TO: Paul Levesque, Rick Klumph, Design Team-Oregon Solutions  
FROM: Vaughn Collins, P.E.  
CC: Dave Boatman P.E., Jeff Johnson, P.E.  
**RE: Evaluation of Flood Durations and associated issues for First Flood Control Project**

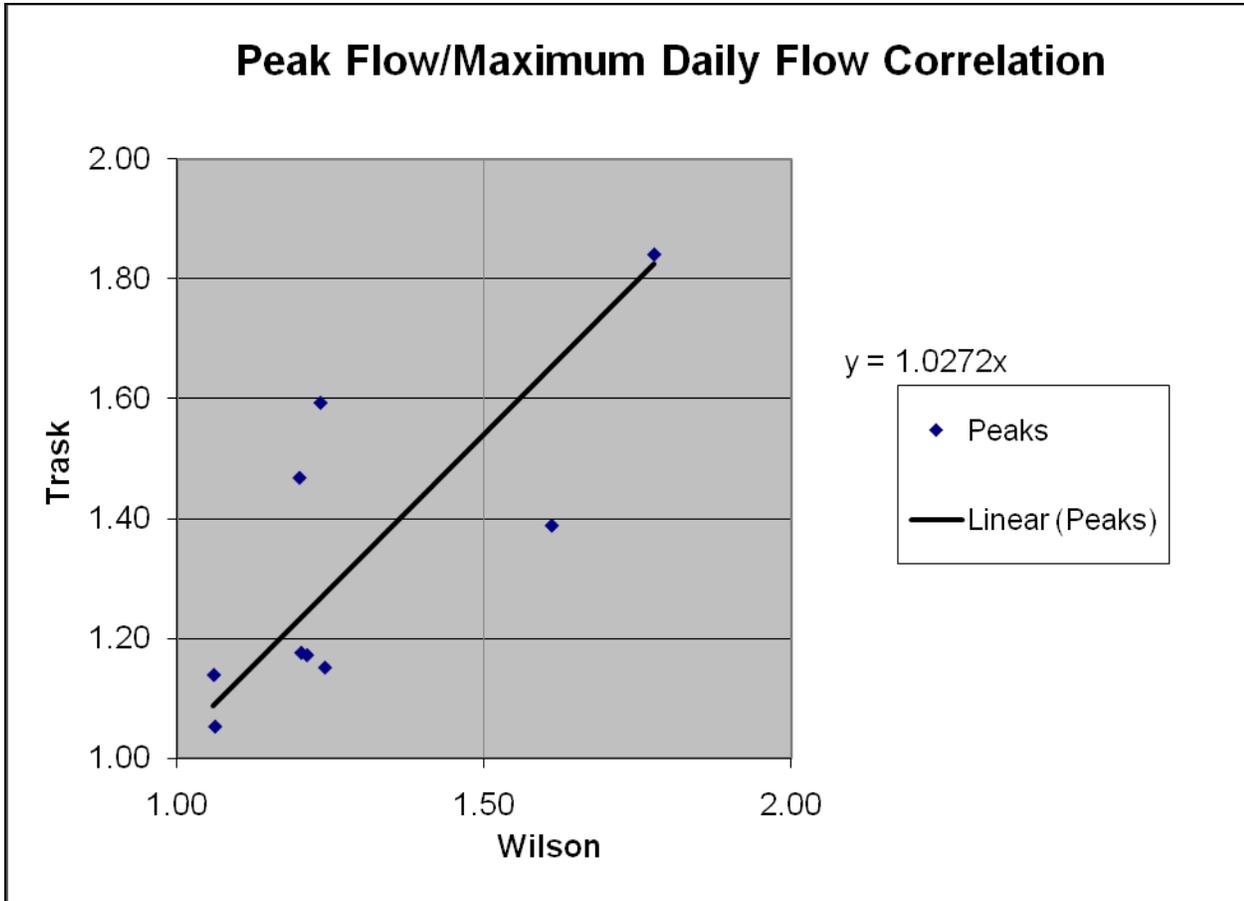
The above figure plots the Wilson and Trask River peaks at the USGS gage sites for all available years. On average, the Trask peak flow is 70% of the Wilson peak, but has varied up to 25% above or below this ratio (yellow and pink lines). In other words, Trask River peaks flows have varied from around 50% to 90% of Wilson River peaks over the years of record.

### Stage and Flow of the Wilson at Blind Slough, and the confluence of the Trask and Tillamook for the 2007 Event

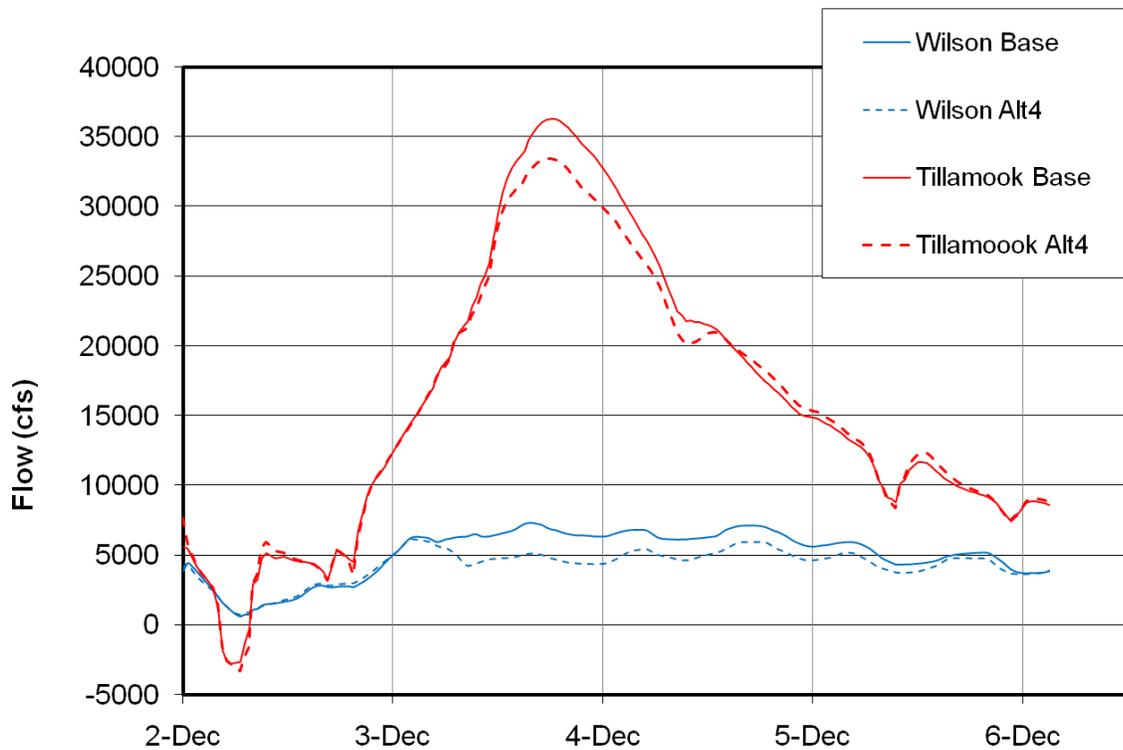
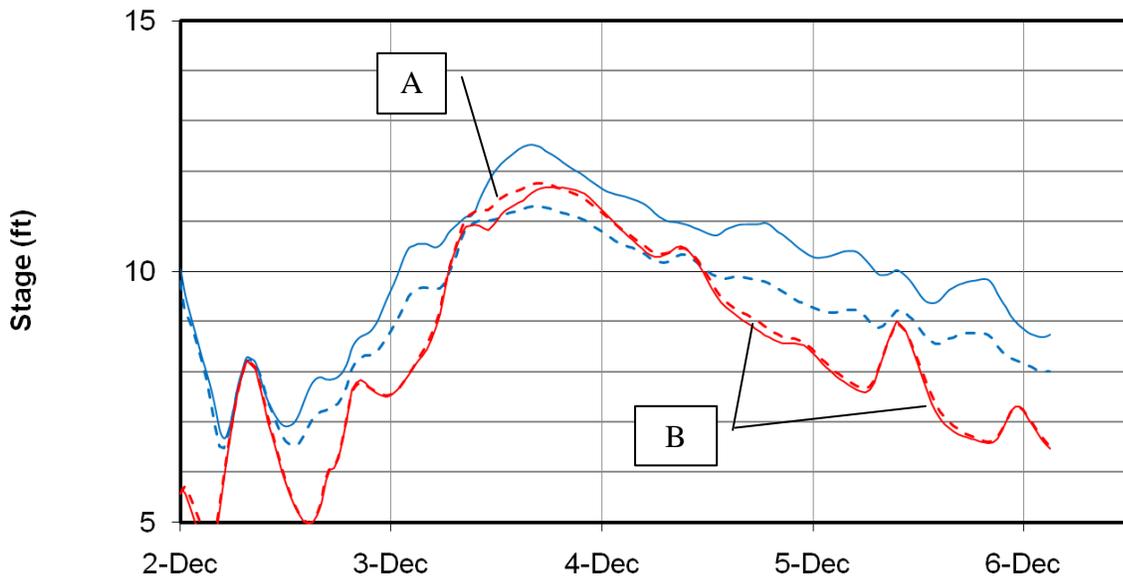
There are changes to flood shape from Alternative 4 on the Tillamook. The two main ones are shown on the figure:

- A) The flood rises earlier, without the slight tidal “bump” shown under existing conditions. It also peaks earlier and initially drops slightly faster. For this flood, the peak is 0.02 ft higher than existing conditions. We expect this change would vary with the relative timing of the high tides and arriving flood waves in different floods.
- B) As the flood recedes, the ebb tide stages drop slightly slower.

In our judgment, the changes shown are not large enough to cause any measurable adverse impacts in this area. The patterns discussed here hold true for all floods evaluated.
